CITY OF ALBUQUERQUE

RE: **Lot 26 Block 7 Unit 4**
6805 Tamarisk NW
Grading and Drainage Plan
Engineers Stamp Date 7/25/2021 (D10D20)
Pad Certification Date 11/8/2021

DRAINAGE AND TRANSPORTATION INFORMATION SHEET (REV 6/2018)

ENGINEER'S SEAL 7/25/21	6805 TAMARISK	DRAWN BY: WCVJ
	GRADING AND DRAINAGE PLAN	DATE: 7-19-21
 1606 CENTRAL AVENUE SE SUITE 201 ALBUQUERQUE, NM 87106 (505) 872-0999		210210070-LAYOUT-7-20-21
		SHEET #
DAVID SOULE P.E. #14522		JOB # 21021070

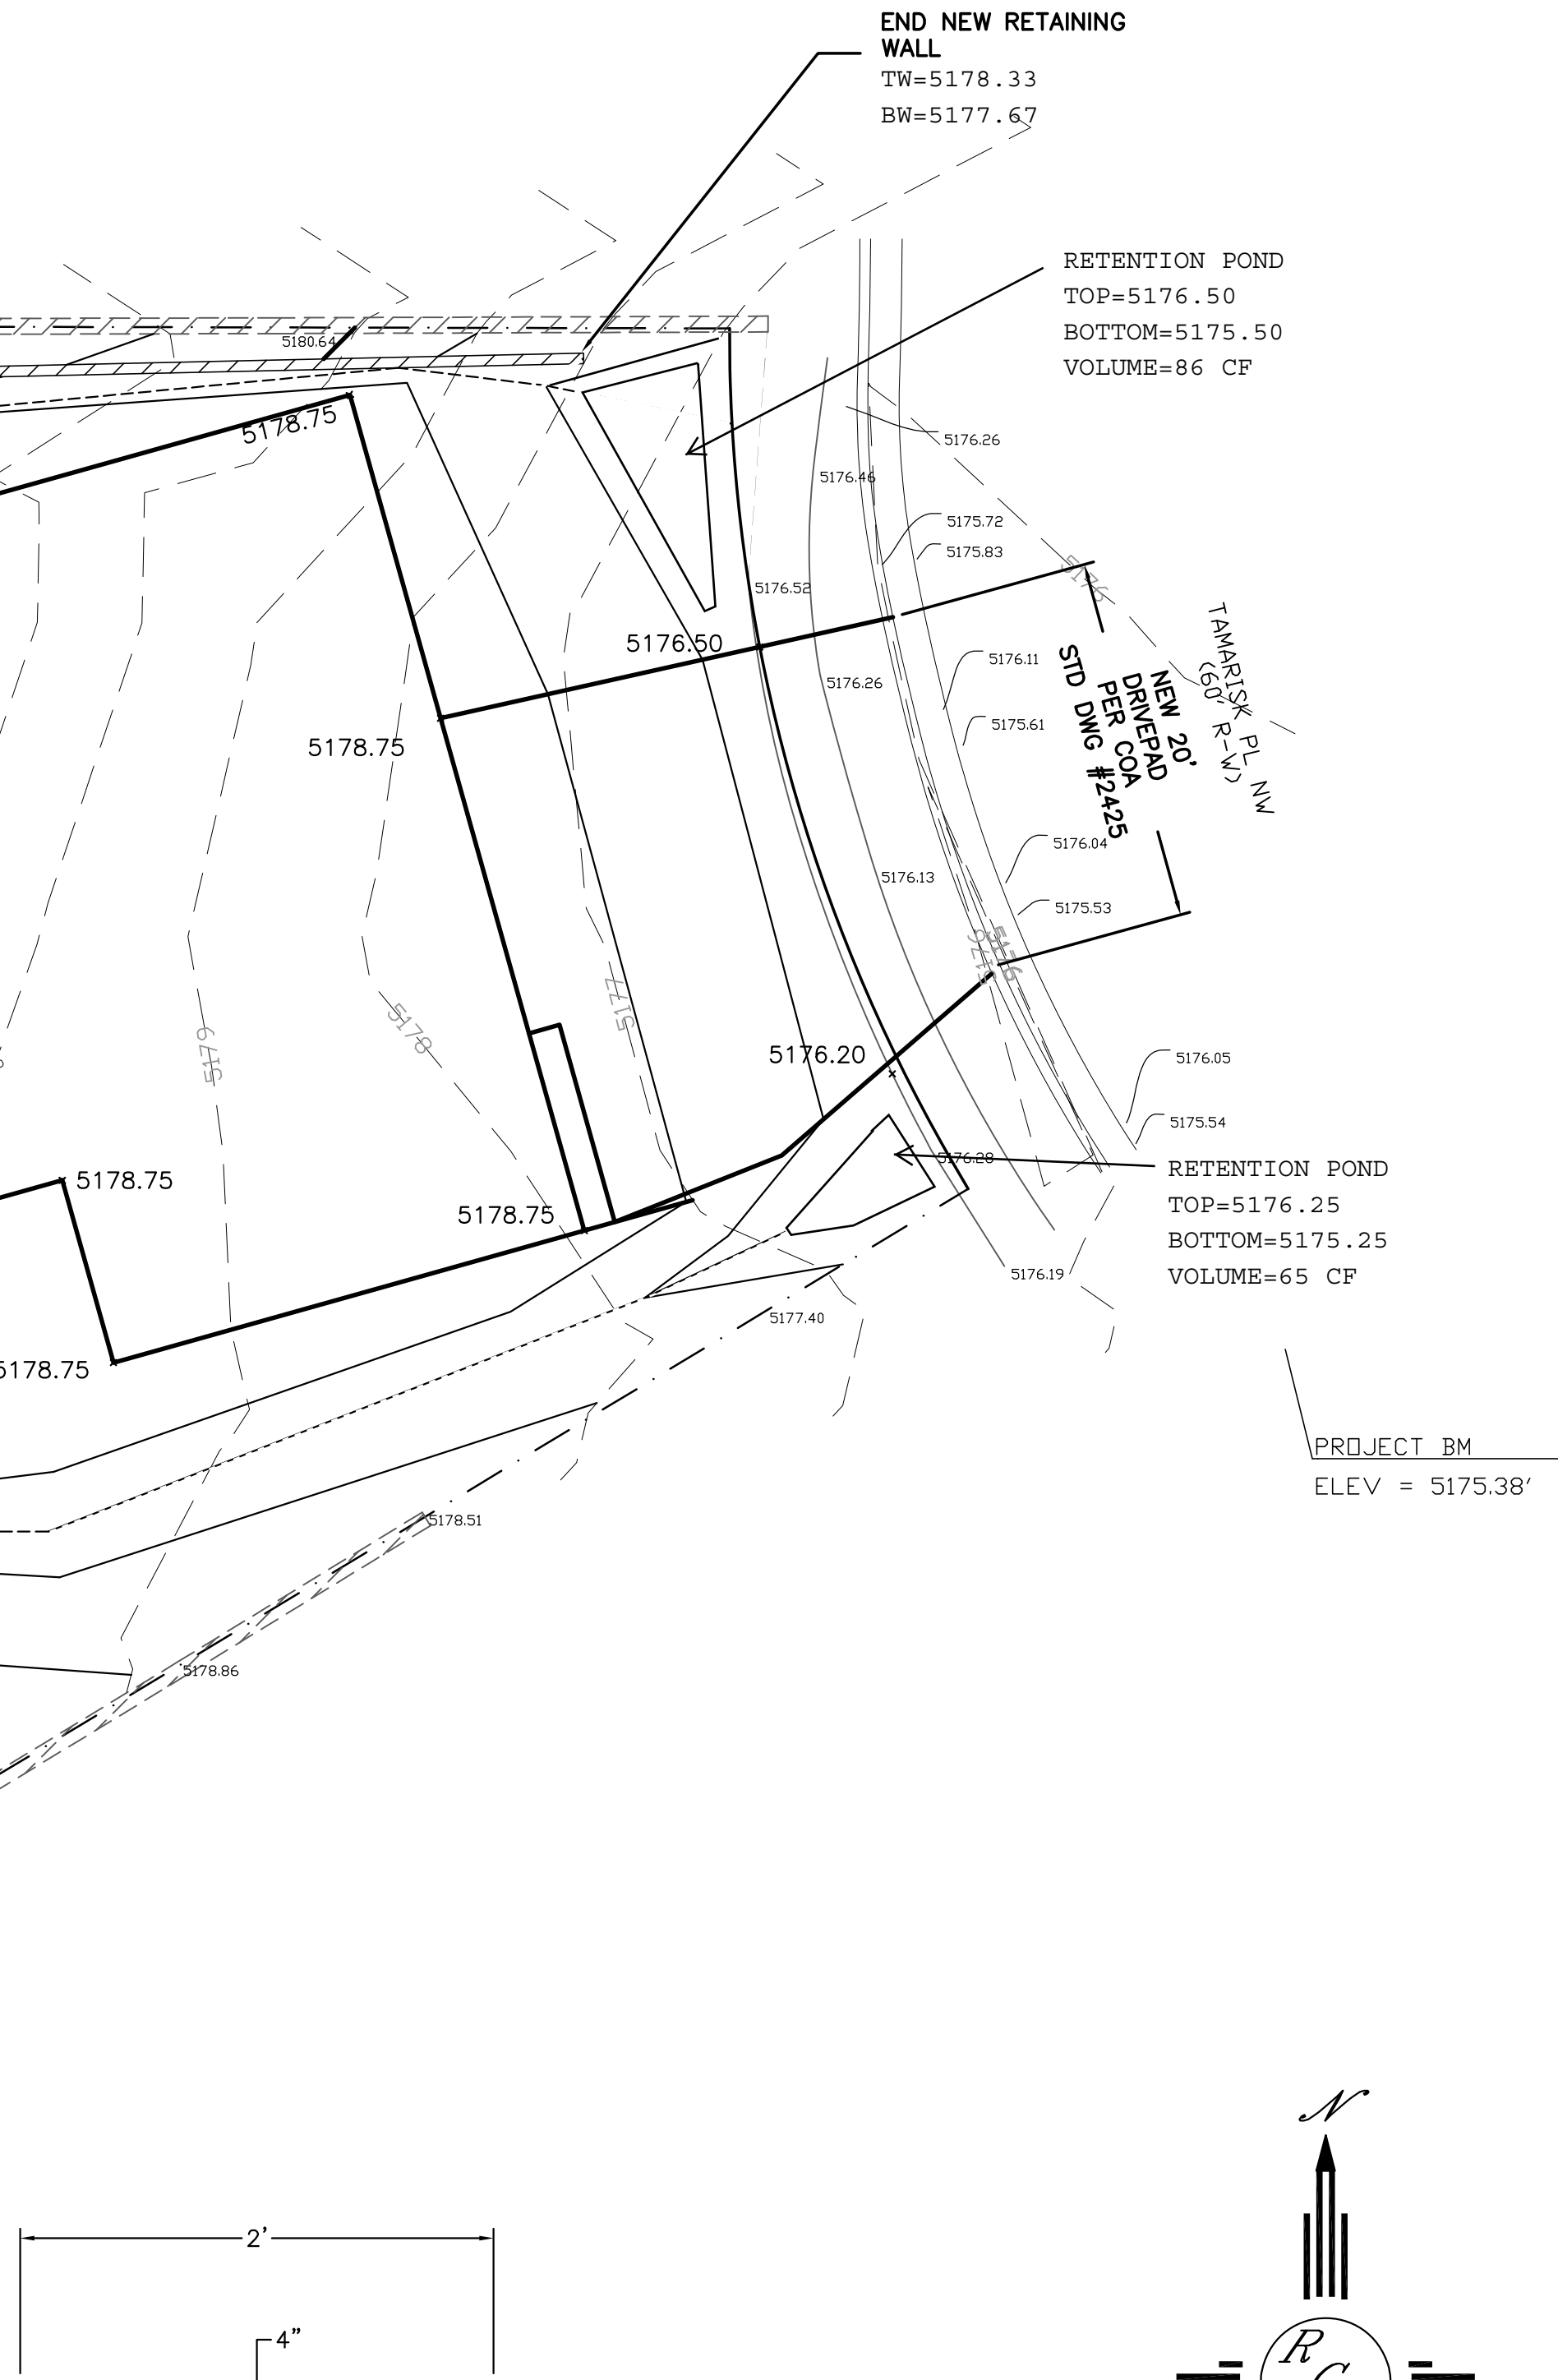
Based upon the information provided in your submittal received 11/8/2021, this plan is approved for Building Permit.

Reiterate to the Owner/Contractor that a separate permit for a garden/retaining wall must be obtained, with the approved G&D plan. Also, advise the owner/contractor not to use dirt as a ramp to climb the curb. If dirt is used it will cause a delay in permitting.

Prior to Certificate of Occupancy release, Engineer Certification per the DPM checklist of this plan will be required.
